**TRUMAN STATE UNIVERSITY**  
*Honor • Celebrate • Pursue*

RE: Addendum No. 1  
Fair Apartments Asbestos Abatement and Demolition Project  
Project No. SP18-23

Project: Truman State University – Missouri Hall  
Phase: Asbestos Abatement  
Date: 03/23/2018  
Consultant: Farmer Environmental Services  
Contact: Brian Farmer, [brian@farmerenv.com](mailto:brian@farmerenv.com)

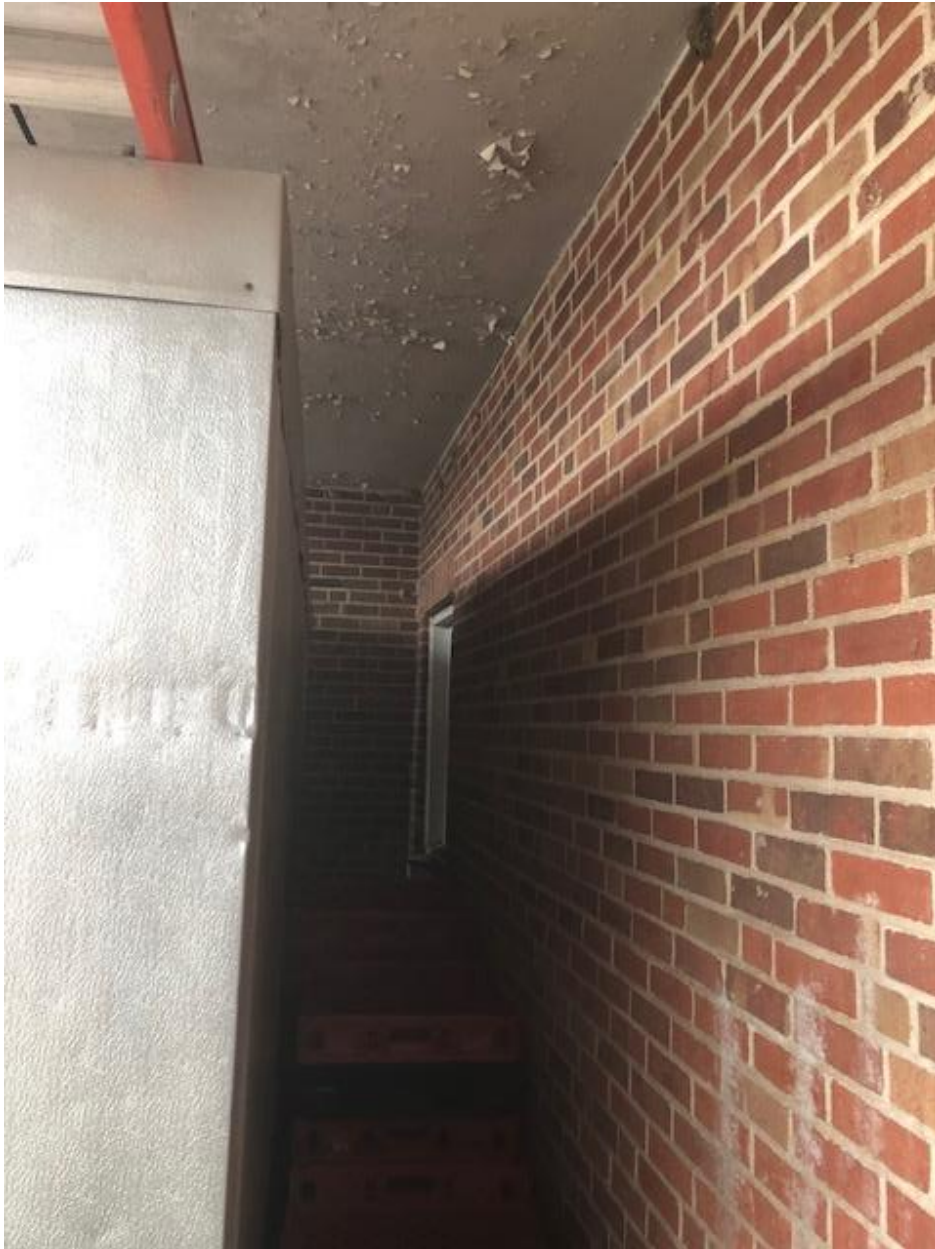
Project Scope of Work: Abatement Contractor will be responsible for the labor, materials, and disposal of one door and one window and all associated door and window caulking.

Asbestos Containing Materials: The window and door caulk are asbestos containing materials.

1. Follow all MDNR, OSHA, and EPA Rules and Regulations.
2. Abatement Contractor is to build a hard barrier on the interior side of window and door opening. Use drop poly and demarcate the area with asbestos caution tape.
3. Remove door and window and all associated window and door caulk.
4. Dispose of all building materials as asbestos containing debris.

Window behind the cooler at Missouri Hall to be removed.

Door on Missouri Hall to be removed.
